Urban Bushland Council WA Inc.  
PO Box 326  
West Perth WA 6872

Appeal – EPA Report 1471

Mangles Bay Marina-Based Tourist Precinct

EPA Report (page 17-18).

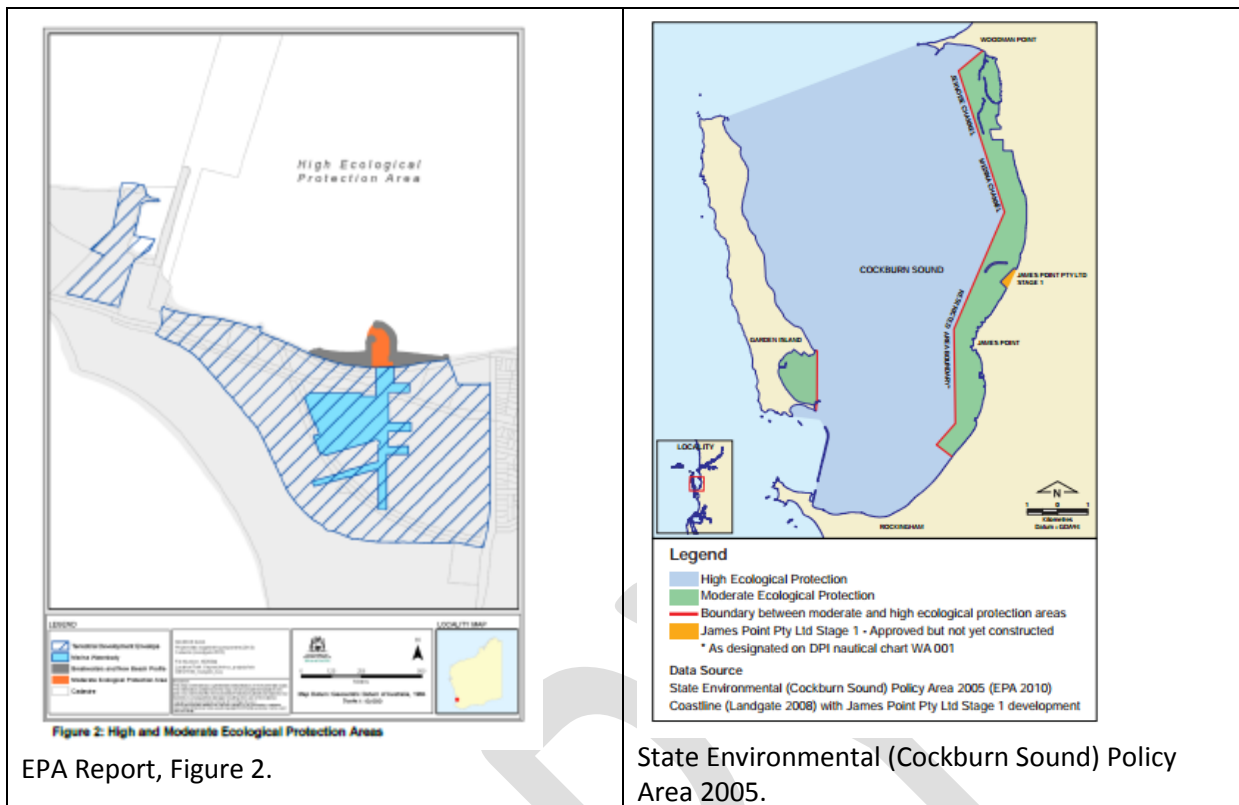
It is incongruous that the current poor water quality in Mangles Bay somehow makes it acceptable to increase water pollution. Again, environmental damage is allowed via an “offset”. Condition 11-10 details the financial arrangements totally \$375,000 over 5 years. There is no calculation or estimates of what the nutrient treatment process will cost in capital and operating costs. Further there is no detail on how much of this funding will be paid by the State Government. Without an estimate of the total cost there is an unknown liability on the state government to fund nutrient treatment.

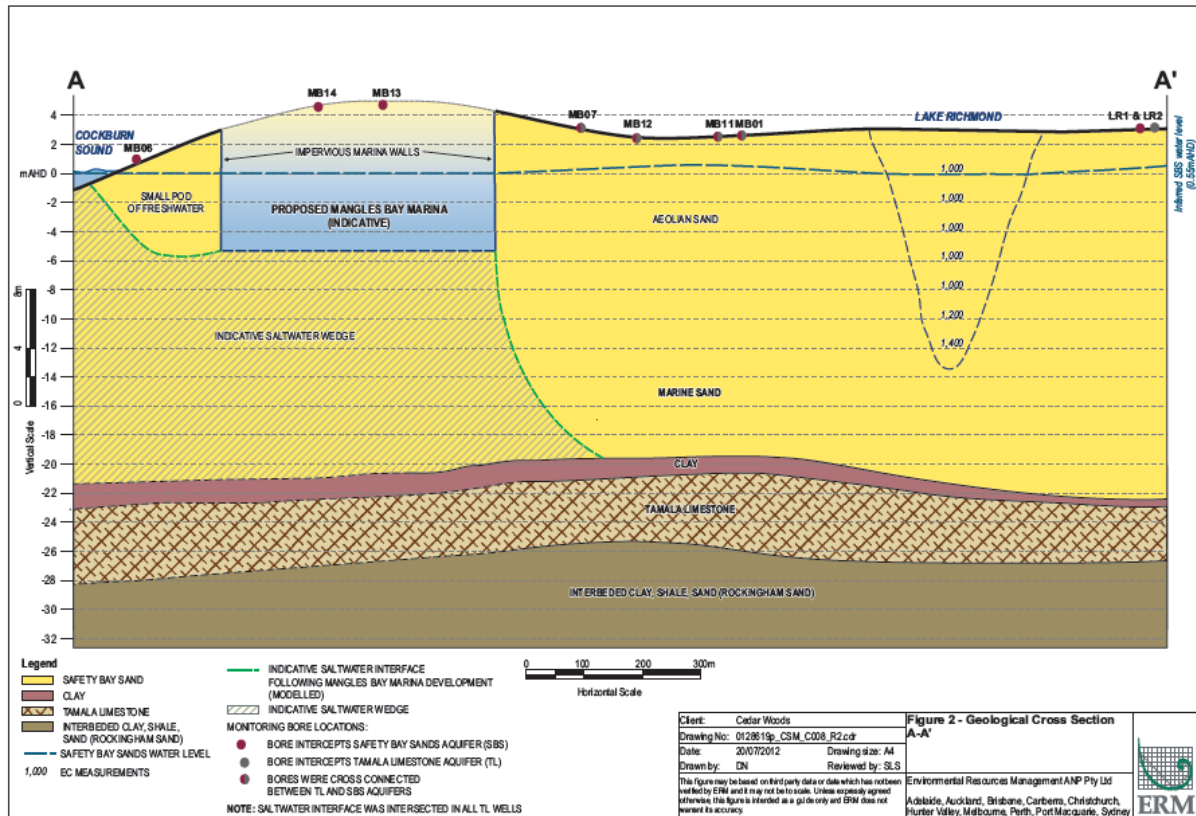
This figure unfortunately is somewhat misleading as the saturated zone is not well defined (saturated and non-saturated sand are both coloured yellow) and there is a simplistic representation of saltwater intrusion. This figure appears to indicate that the “Safety Bay water level” represents the top of a uniform body of ground water, which is far from reality, as we have seen with the ground water varying from fresh to highly saline (Annual Report, and our cross-sections in the previous section).

Further, the “small pod of freshwater” marked on the figure below MB06 is currently saline. March 2011 an EC result from MB06 has measured EC values of 23,000 – 40,000  $\mu\text{S}/\text{cm}$  (0.5 – 7 m depth). This error appears to have been introduced during modelling as the scope of the modelling project did not include current salinities above the sea water wedge.

The salt water wedge figure gives the false impression that only the hatched area has increased salinity levels. However this is an over-simplification of ground water salinity in the area.

Above: modelled salinity under existing conditions (left) and duplication of SDOOL (right), at -12 m. (Data does not match that shown in Annual Report).

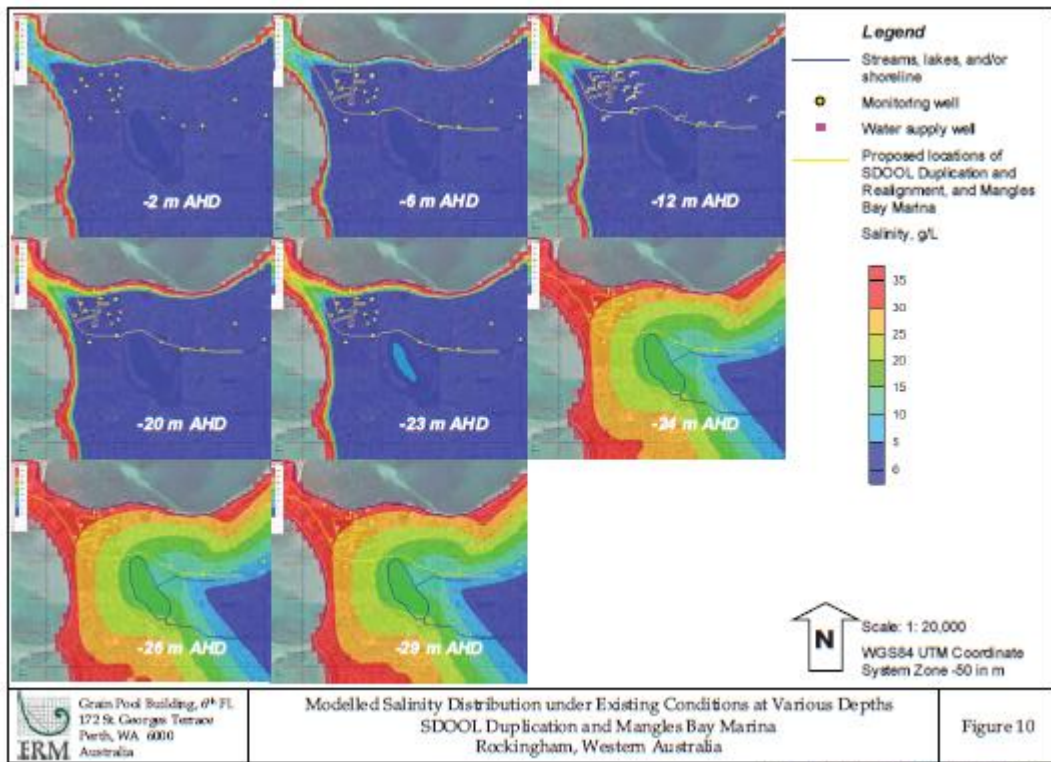
The erroneous salinity figures are further abused when modelling the current salinity for the SDOOL relocation. Salinity at -12 m again is depicted as being very low (key hard to read), which does not reflect reality as described in the Annual Report.

Above from: PER Part I (does not match data in Annual Report).

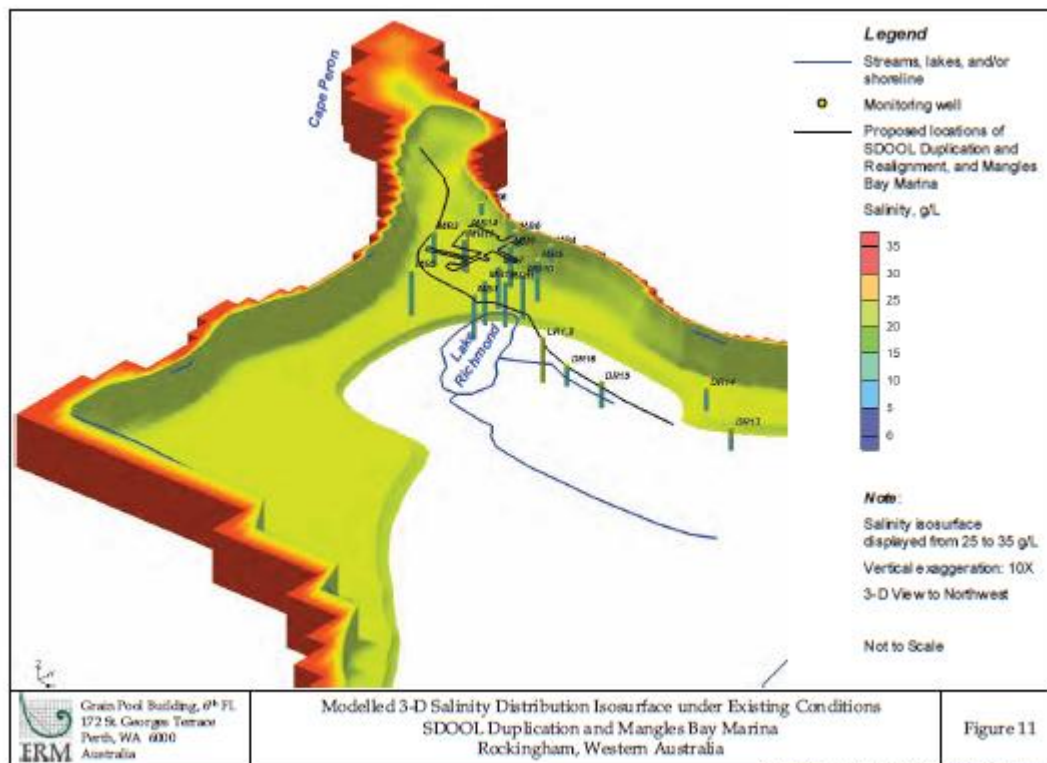
This Figure is misleading as it states it is showing “Existing Conditions” but these conditions do not match the salinity results in the Annual Report. Salinity levels measured from the monitoring bores

in March 2011 shows a distinct increase in salinity at a depth of 20 m. This Figure shows the high salinity layer occurring at a depth of 24 m. It is assumed that this is an average level, although there is no date on the Figure. Figure 11 (below) is a cross-sectional view and shows the “Average salt water interface during monitoring” at 24 m, although again there are no dates on the Figure.

Above: Dashed lines show the proponents modelled movement of the sea water wedge and the unknown effect on ground water salinity located above the wedge (shown as orange and yellow).

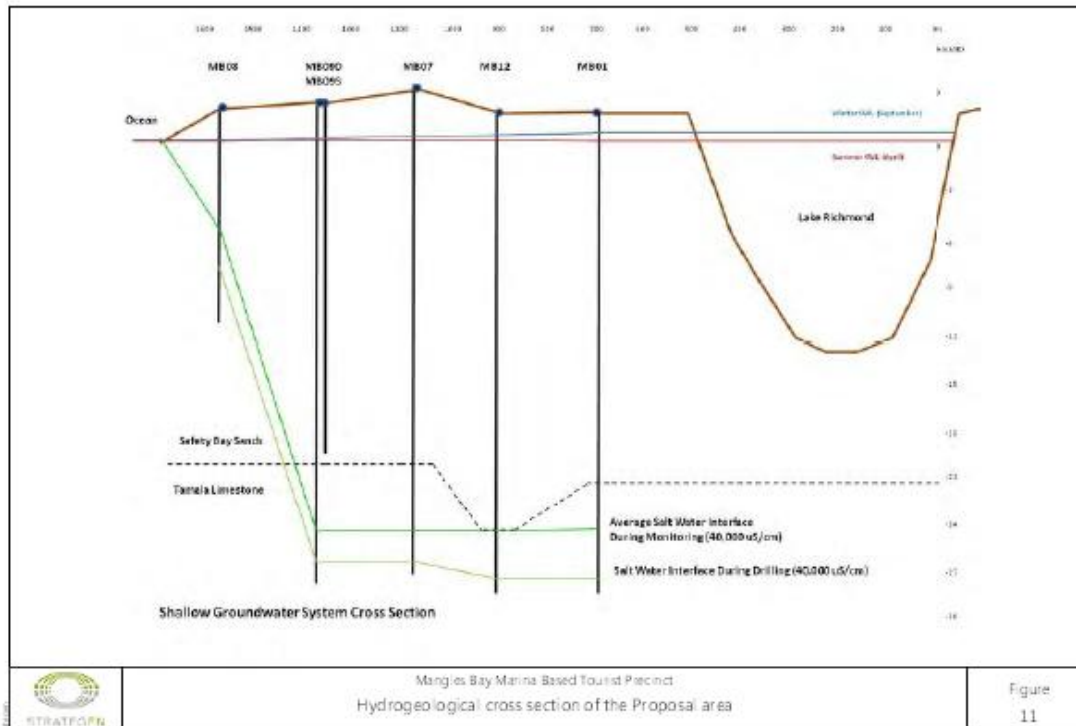
The figure below shows the modelled movement of the sea water wedge and the unknown effect on the saline water upslope (shown as orange and yellow). Intrusion of the dense sea water will of course displace the saline water in the soil water pores between the wedge and the lake. What is the nature of this displacement? Will the saline water be displaced upslope towards Lake Richmond increasing the salinity in the freshwater lake and impacting upon the two Endangered communities located there?

**Outcome Sought 16b:** The EPA Chairman to request modelling of the movement of brackish water towards Lake Richmond (above the sea water wedge) to assess the impact of groundwater quality on the TEC of Lake Richmond Thrombolites, including the effects of changes in EC, pH, calcium, bicarbonate and carbonate.
